**STAFF REPORT**  
**COMMUNITY DEVELOPMENT DEPARTMENT**

HEARING DATE: April 1, 2021  
TO: Planning & Zoning Commission  
FROM: Sonya Allen, Associate Planner  
208-884-5533  
SUBJECT: H-2021-0007 – Seasons at Meridian/Winco Wells Subdivision  
H-2020-0118 – Volante Investments  
LOCATION: 2600 & 2700 E. Overland Rd., in the SE ¼ of Section 17, Township 3N., Range 1E. (Parcels: S1117438626, S1117438451)

C. Site Plan for Multi-Family Portion of Development (date: 1/14/2020)

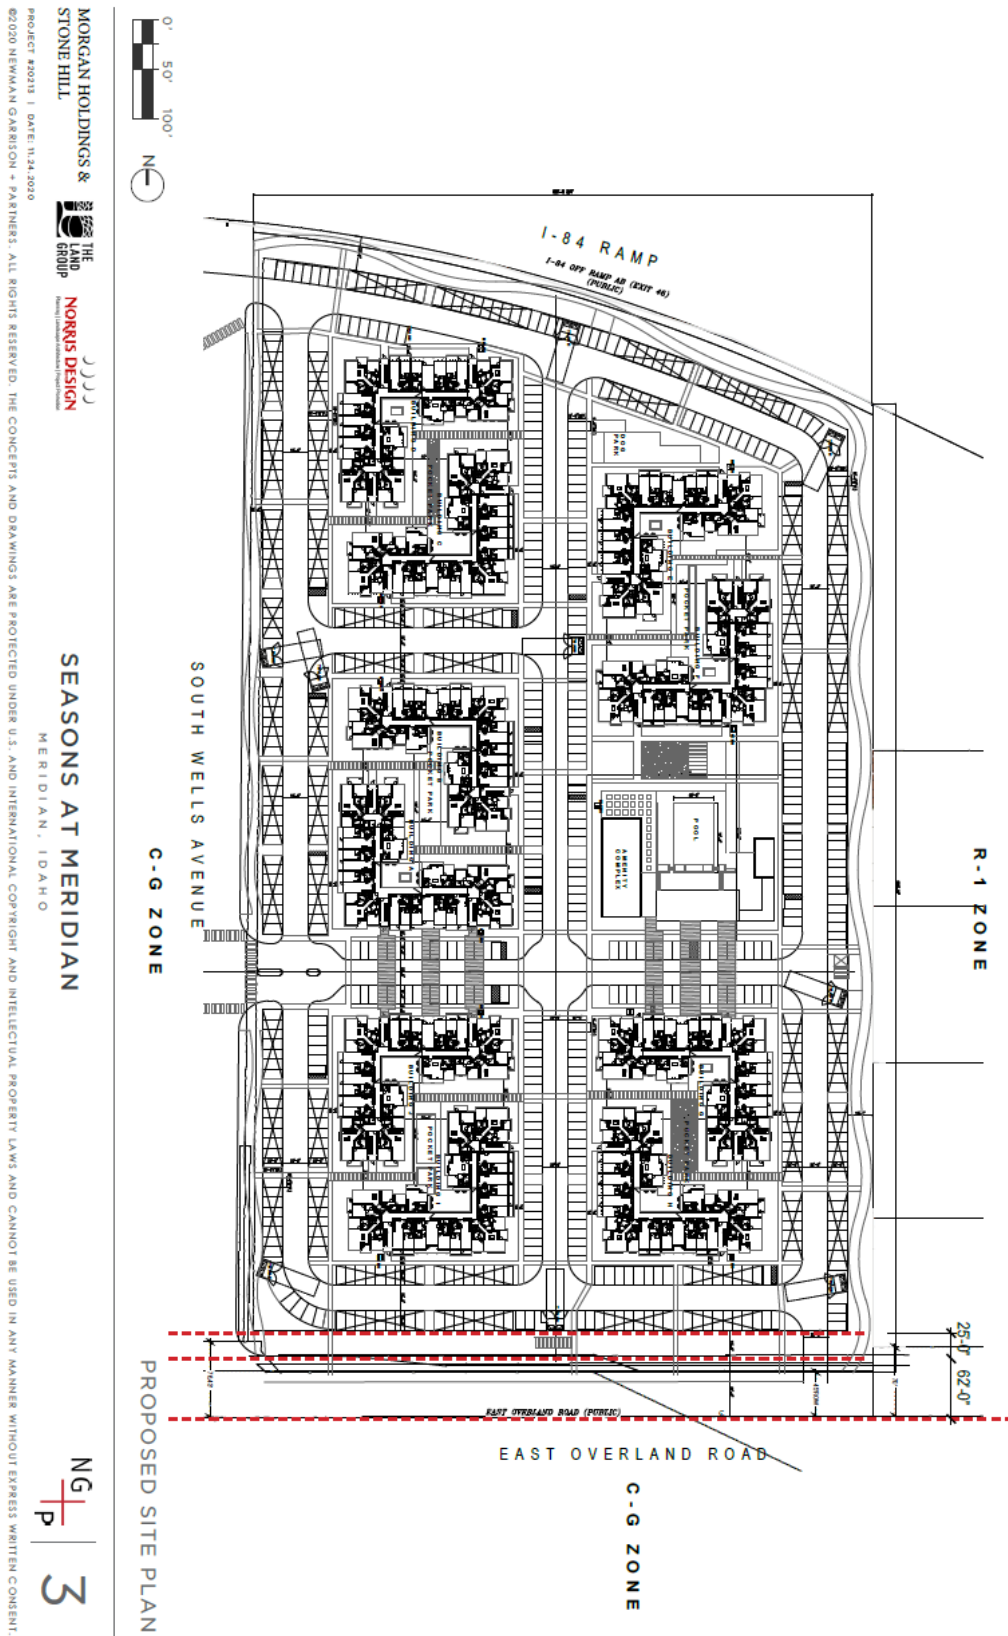
Because the existing 7-foot wide attached sidewalk along Overland Rd. is in good condition, Staff does not recommend replacement with a new detached sidewalk; however, if/when it's replaced in the future, a detached sidewalk should be constructed. Attached sidewalks are depicted on the landscape plan along E. Cinema Dr. and S. Wells Ave., both local streets; the landscape plan submitted for the CUP application depicts a meandering detached sidewalk along Wells – **this discrepancy should be corrected.**

Required street buffer widths are as follows: 25-feet along E. Overland Rd., an arterial street; 10-feet along S. Wells Ave. and E. Cinema Dr., both local streets; and 35-feet along the I-84 off-ramp, an entryway corridor. Street buffer widths are proposed on the landscape plan in accord with these standards. **The plan is missing the street buffer along I-84 on the west parcel (Lot 2, Block 1); the plan should be revised to include this buffer.**

**The number of trees proposed in buffers meets the minimum standard; however, a mix of trees and shrubs with lawn or other vegetative groundcover is required – shrubs should be added to the buffers in accord with UDC 11-3B-7C.3a. Street buffers are required to be placed in a common lot or on a permanent dedicated buffer, maintained by the property owner or business owners' association; the plat should be revised accordingly.**

Street buffer landscaping is required to be provided with the subdivision improvements as noted above in Section VI.B. **The site and landscape plans should be revised to include the additional ROW dedication and right-turn lane for Overland Rd.; the street buffer shall be located outside of the ultimate ROW for these improvements.**
